# Technical Bulletin

Subject: Brake Vibration Damper Application

Number  
9204

This bulletin supersedes Technical Bulletin Group 4, Number 9108, Book H, pages 121-123.

Figure 2

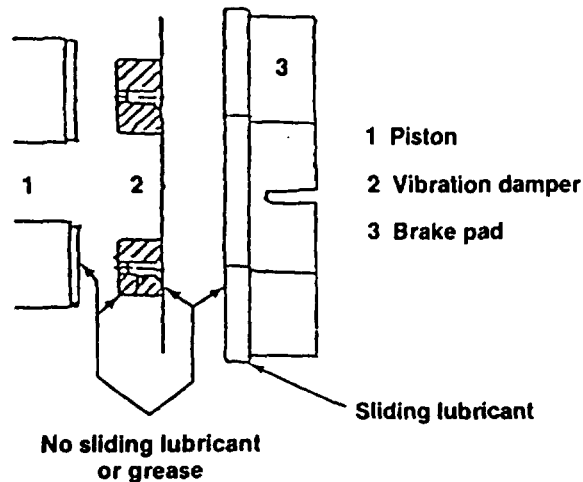
Clean seating and guide surface of brake caliper with mineral spirits before installing vibration dampers and pads. Lubricants or grease must not be used in conjunction with vibration dampers. A light coat of sliding lubricant (Optimoly HT Part Number 000 043 004 00) may be applied on the guide surface of the pad carrier plate (Figure 2).
